[Docket No. 2001-SW-53-AD]

Airworthiness Directives; Bell Helicopter Textron, A Division of Textron Canada Model 407 Helicopters

ACTION: Supplemental notice of proposed rulemaking; reopening of comment period.

Figure 1. Preflight Check of the tailboom

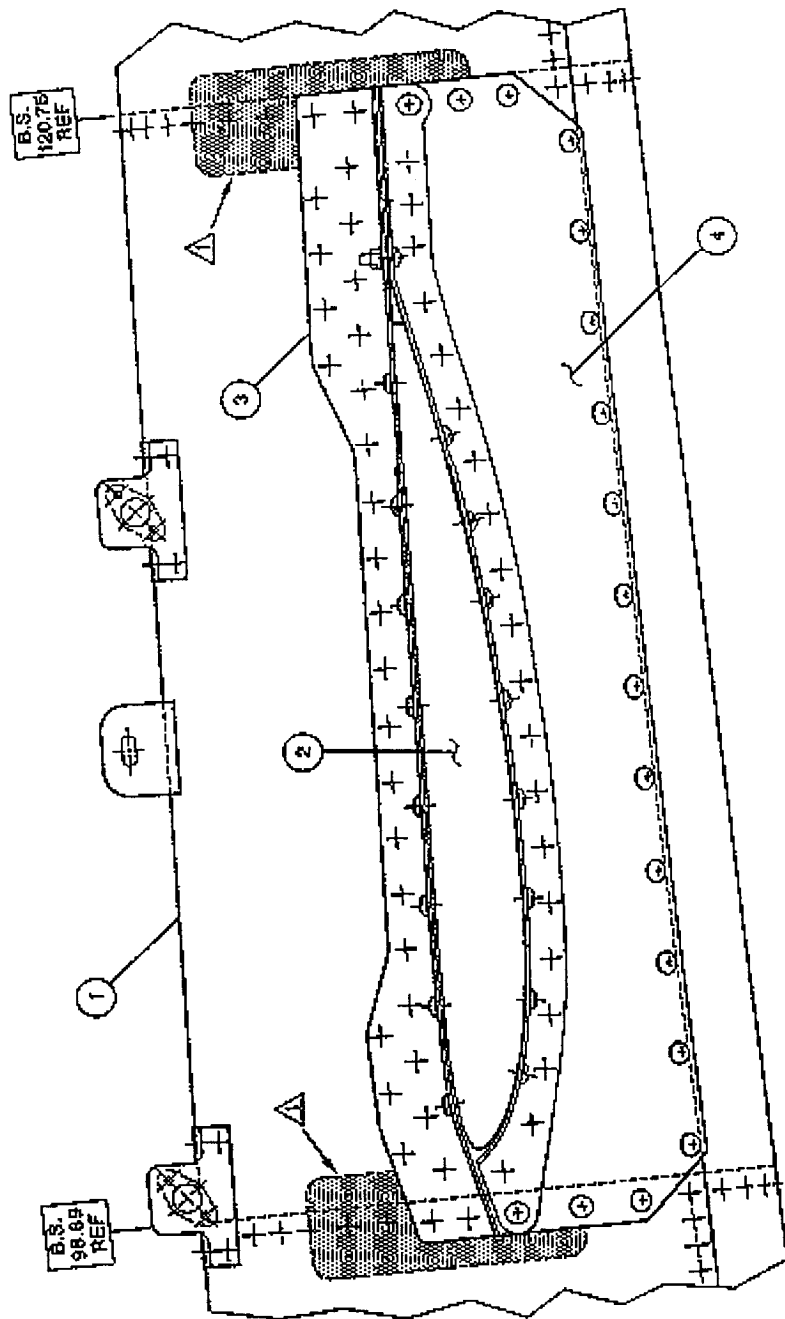
| Applicable tailboom | Compliance time | Actions | In accordance with |
|---|-------------------------------------|--|----------------------|
| (a) Tailboom, P/N 407-030-801-101 and -105, that have not been modified in accordance with Bell ASB 407-01-048, Revision B, dated April 25, 2002. | Before the first flight of each day | Visually check the tailboom for cracks. An owner/operator (pilot) holding at least a private pilot certificate may perform the visual check required by this paragraph, but must enter compliance with this paragraph into the helicopter records in accordance with 14 CFR 43.11 and 91.417(a)(2)(v). | Figure 1 of this AD. |

- △ Examine these areas for cracks on left side of tailboom only.
- 2. Horizontal stabilizer not shown for clarity.
